JURUPA COMMUNITY SERVICES DISTRICT

ADDENDUM NO. 3

TO THE PLANS AND SPECIFICATIONS FOR RECYCLED WATER PROGRAM – SEGMENT 2 FINAL DESIGN JCSD P.N. C215078

JURUPA COMMUNITY SERVICES DISTRICT SHEET NO. BENCHMARK: SEE SHEET 1 CITY OF EASTVALE/JURUPA VALLEY, CALIFORNIA JCSD RECYCLED WATER PROGRAM PROJECT SEGMENT 2 NOTES, LEGEND, ABBREVIATIONS 26_{SHEETS} AND INDEX SHEET W.O.

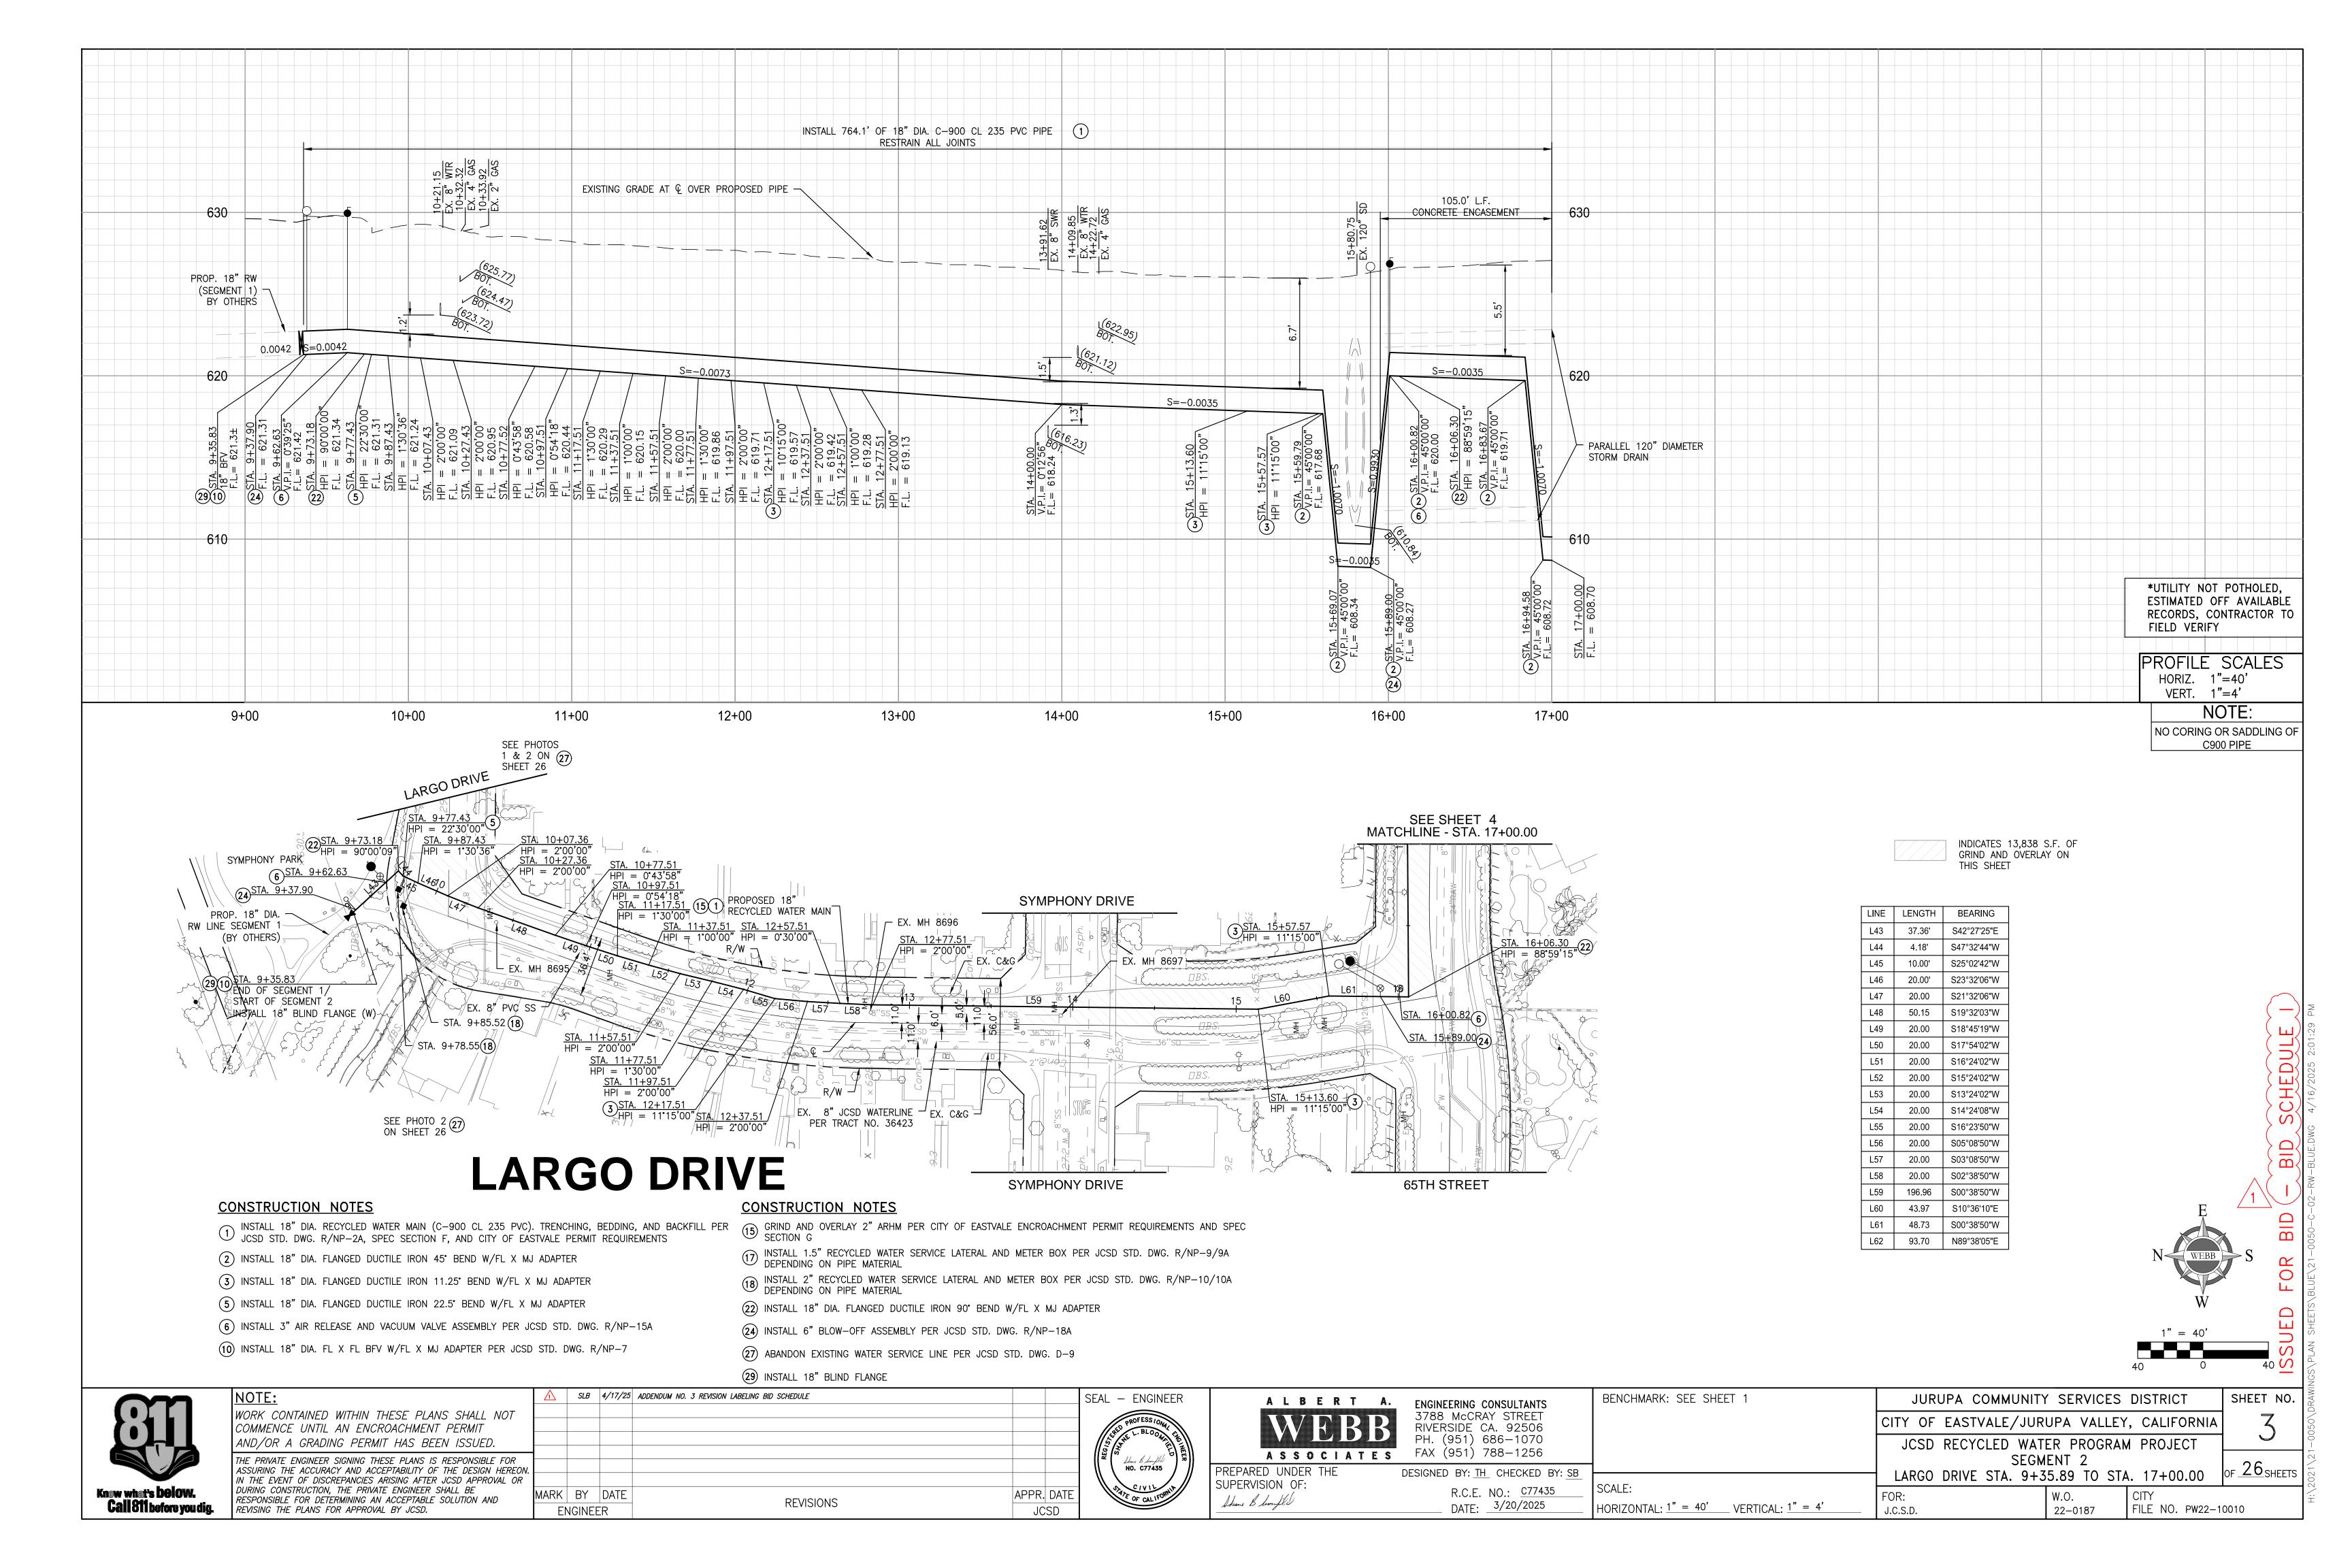
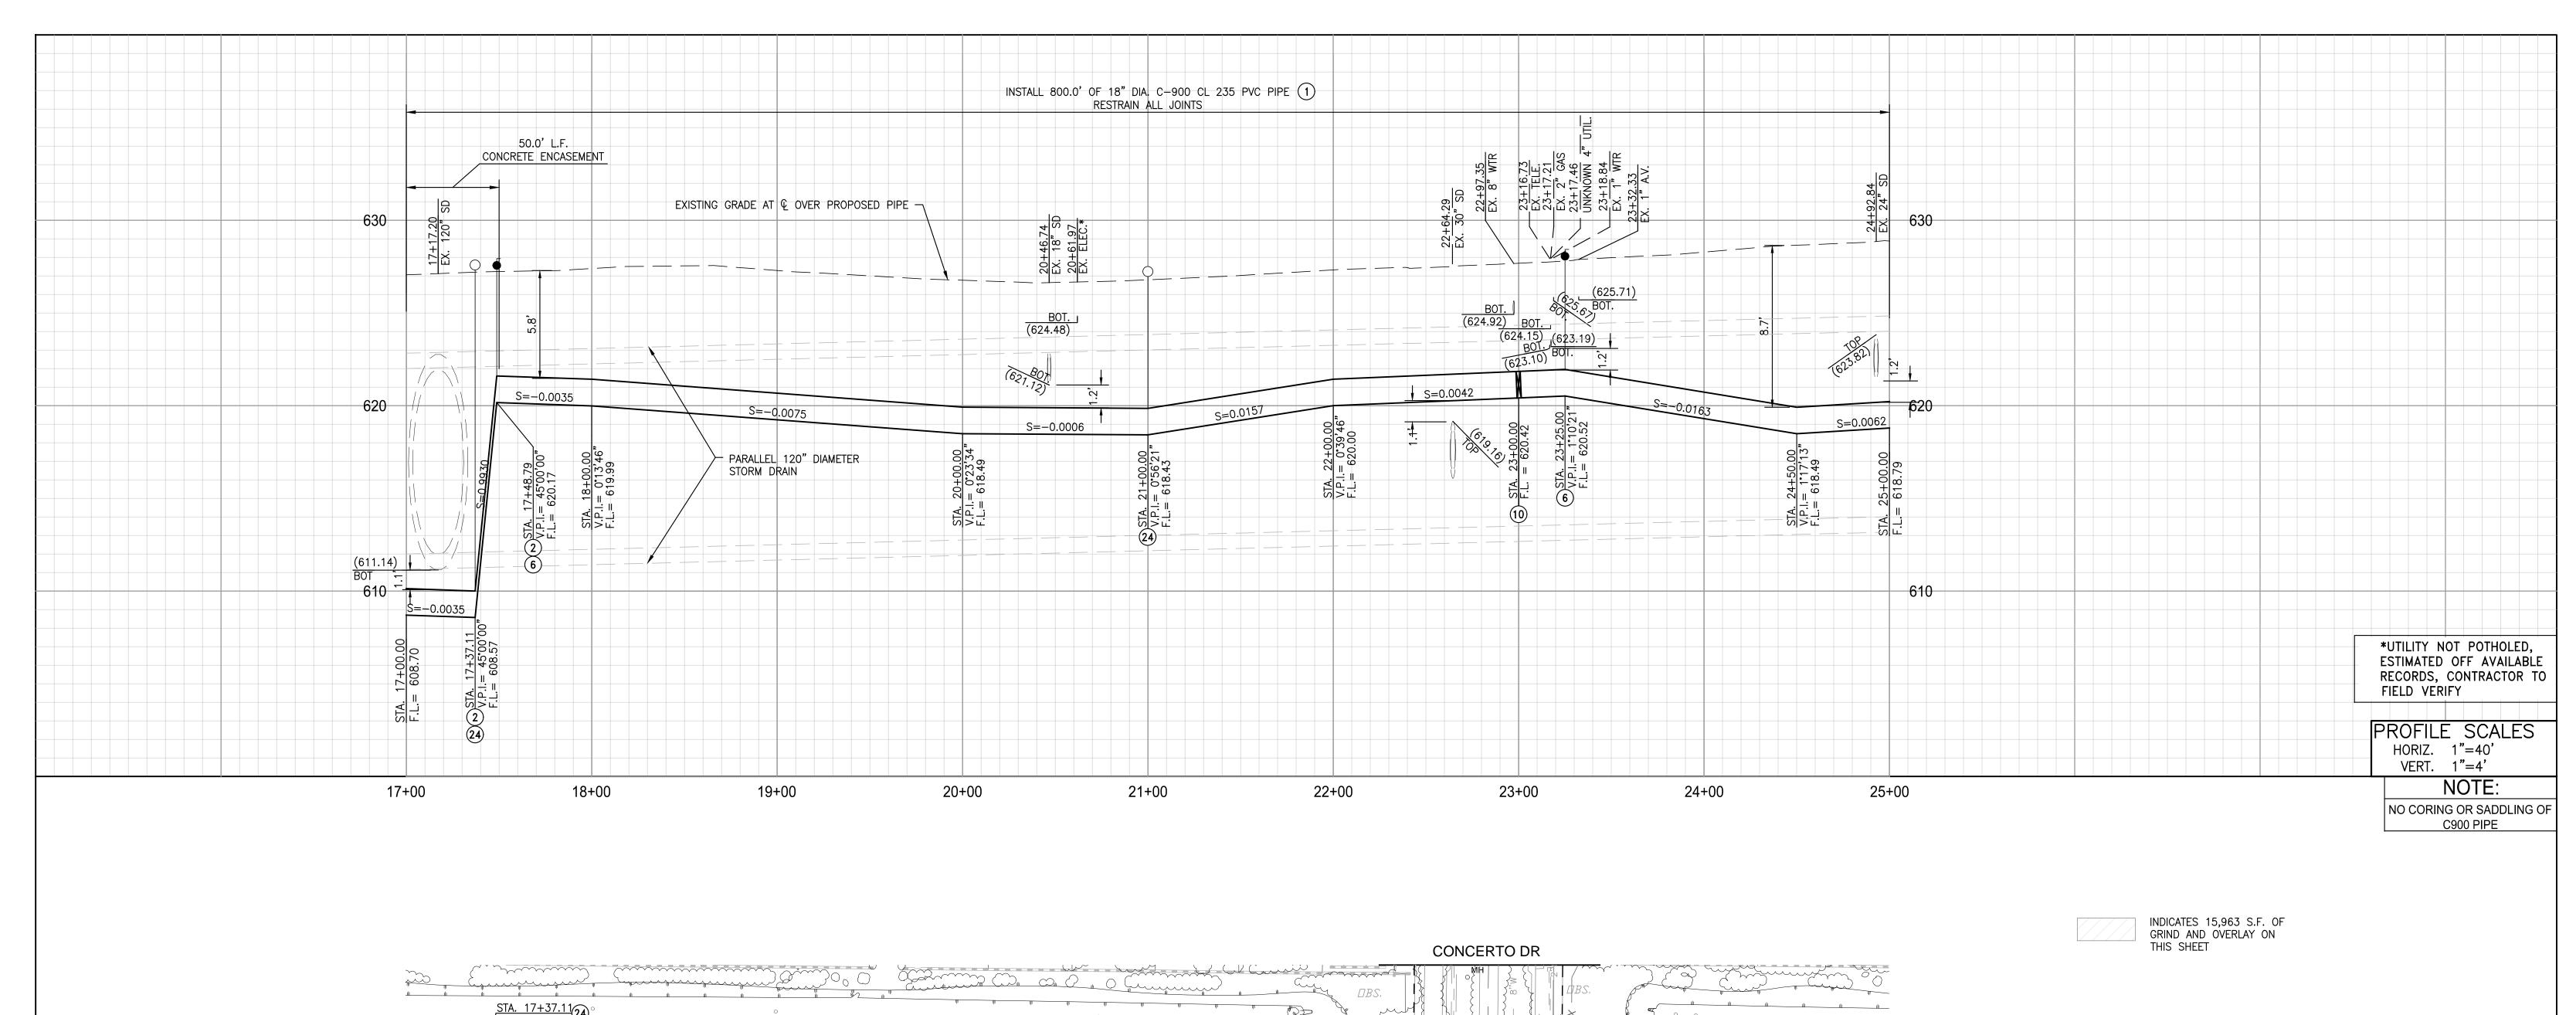
Additionally, the callout at the terminus of the proposed 65th Street recycled waterline has been revised to account for the existing Segment 3 18-inch cross and 18-inch butterfly valves that will be installed prior to Segment 2 construction. As a result, the stationing has been revised to indicate that the terminus of the Segment 2 waterline is STA 109+05.82, which has been updated in both plan and profile, as well as it's Sheet Title reference on Sheet 14 and Sheet 2.

\triangle	SLB	4/17/25	ADDENDUM NO. 3 REVISION FOR STATIONING PER SEGMENT 3 VALVE INSTALLATION		
_						
	MARK	BY	DATE	DEVICIONIC	APPR.	DATE
ENGINEER		ĒR	REVISIONS		JCSD	
	-
